LINCOLN CITY/LANCASTER COUNTY PLANNING STAFF REPORT

Revised Staff Report

P.A.S.: Change of Zone #3369
Special Permit #1978

Stone Ridge Apartments (Revised)

SITE PLAN

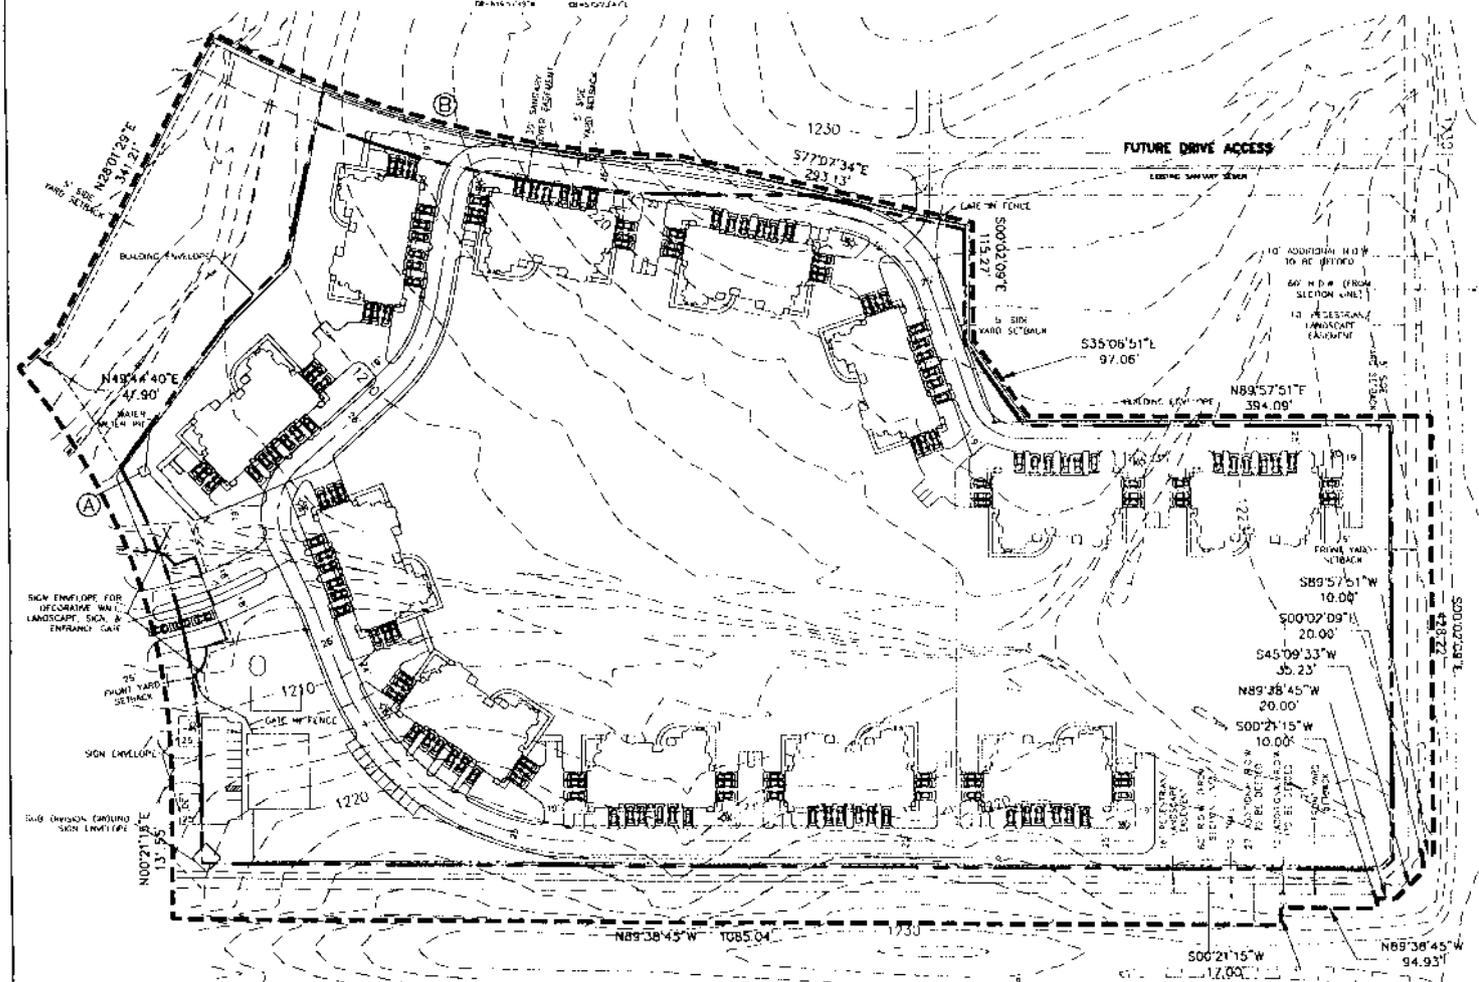
4. The apartment buildings are accessed by an internal private driveway. That portion of the driveway serving the apartments along the north boundary shows a connection to the future street north of the complex. The south portion is a dead-end drive approximately 1,100 in length. While this project is not subject to the requirements of LMC Section 26.23.080 that limits dead-end streets to 1,000' in length and serving no more than 40 dwelling units, the standard was developed with public health and safety in mind. In this case, the concern is the potential number of people and amount of property at risk if the drive becomes blocked for some reason. With only one means of ingress/egress to the buildings on the south, there is no alternate way for both emergency responders to get in or for residents to get out in the case of an emergency. An acceptable solution to the access problem (that would also enhance pedestrian circulation within the complex) is to connect the north and south drives by an

5. Sidewalks are not required by the Zoning Ordinance or Design Standards in the interior of this development, and none are shown. As a result, the development does not have pedestrian connections to surrounding areas, and there is no attempt to accommodate pedestrian circulation within the development. This type of design is contrary to the Comprehensive Plan which encourages connectivity among neighborhoods, and encourages the accommodation of pedestrian facilities to help increase mobility, decrease dependence upon automobiles and reduce traffic congestion.

Sidewalks should be installed along at least one side of the drive throughout the complex, and sidewalk connections should also be made that allow direct access to South 27th Street, Yankee Hill Road, Hollynn Lane, and to the unlabeled building in the southwest corner of the site. Sidewalks should also be installed along both sides of the drive connecting to the 'Future Drive Access' noted north of the site.

6. The two sign envelopes shown between the unlabeled building and Hollynn Lane are not allowed by the zoning ordinance and must be removed. Additionally, all sign envelopes must be indicated on the landscape plan as required by the Zoning Ordinance.

7. The unlabeled building at the southwest corner of the site is presumed to be a clubhouse. Clubhouses are allowed as an accessory use to the apartment complex, and are for the use of the residents living there - not the general public. To enhance the accessibility for the residents of the complex, the unlabeled clubhouse and parking area should be designed with access to the internal road system, and not from the adjacent public street (Hollynn Lane) as shown. A sidewalk connection from the internal sidewalk system to the building should also be provided.

12. Note #5 relating to lot dimensions and reductions in lots under General Site Notes is not applicable and should be deleted. Also, note #10 relating to sidewalks not being required should be deleted.

14. The plan shows required parking being provided by tandem parking for all units at each building throughout the development. That is, one parking space is provided in the garage, and the second is in the driveway. This is an exception to the parking standards, but the Zoning Ordinance allows it to be waived through approval of the plan as part of the C.U.P. Using tandem parking, the amount of off-street parking shown complies with the requirements of the Zoning Ordinance.

1.1.1 Provide a drive across the dam connecting the north and south access drives.

1.1.2 Provide a sidewalk along one side of the drive throughout the complex, with sidewalk connections made to allow direct access to South 27th Street, Yankee Hill Road, Hollynn Lane, to the unlabeled building, and installed along both sides of the drive connecting to the 'Future Drive Access' noted north of the site.

1.1.3 Delete the two sign envelopes shown between the clubhouse and Hollynn Lane. The landscape plan must also be revised to show all remaining sign envelopes.

1.1.6 Delete notes #5 and #10 under General Site Notes.

1.1.7 Label all buildings and structures along with their purpose, and add the number of dwelling units per structure.

1.1.8 Show the unlabeled clubhouse with vehicular access from the internal road system, with the access drive off Hollynn Lane deleted.

GRADING & DRAINAGE PLAN

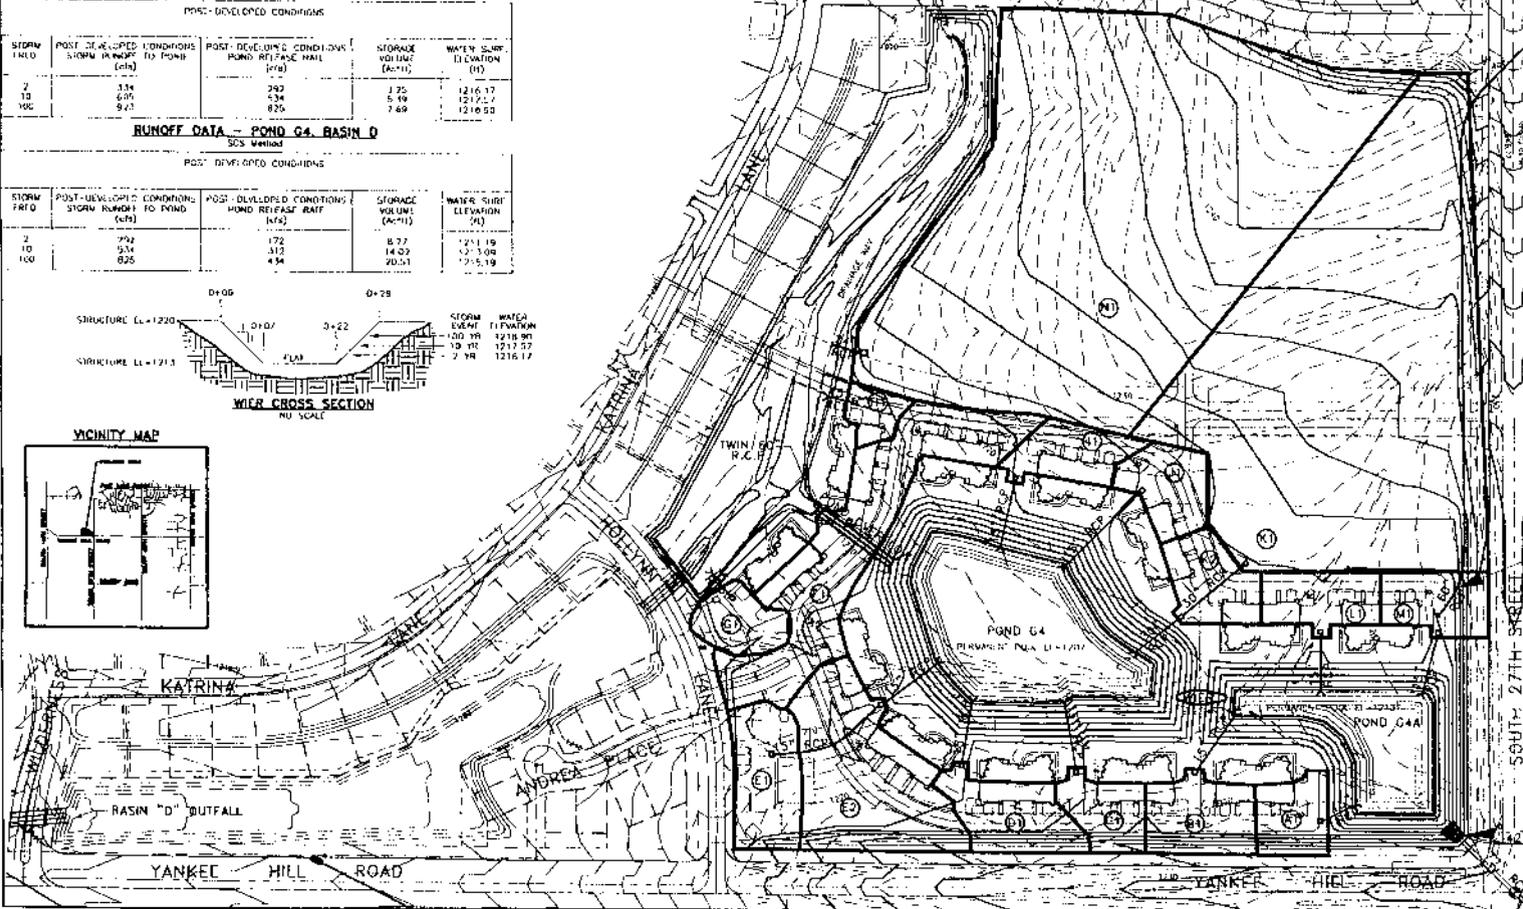
9. As designed, the outlet pipes do not allow the detention facilities to drain completely in order to create permanent pools of water. These pools are intended to be large enough to allow for blue water conditions so they may serve as an amenity for the development. However, the City of Lincoln Design Standards require the outlet pipe for such ponds to be at a level that will allow the facility to drain completely. This standard exists to facilitate the removal of the sediment that will accumulate at the bottom over time.

1. The proposed storm water detention does not meet design standards. The study shows the post development 2 and 10 year flows do not match pre-development. The 2 year post development flows exceed design standard requirements by 60% and are unacceptable. Design standards require that retention facilities with permanent pools be designed with an outlet that allow the retention facility to be drained. The permanent pools for this development have no provisions to drain the permanent pools. The permanent pool for pond G-4 is entirely below the downstream outlet channel.

Energy dissipation must be provided at the outlet of the detention pond. Final design of the cell must include data showing the effective dissipation. Design standards require an emergency overflow. Design and flow data for the emergency spillway should be provided.

4. The open channel along the west side of this development is shown. Design standards require evaluation to determine what measures are needed to avoid bottom scour and bank cutting. Headwater calculations should be provided for the box culvert at Hollynn Lane to show depth of flow along this ditch.

5. Consideration should be given to connecting the north and south portions of the apartments by a road connection across the dam between the 2 proposed detention areas. The connection is desirable to provide more than one means of ingress and egress because of the number of apartments and lengths of the connecting drives.
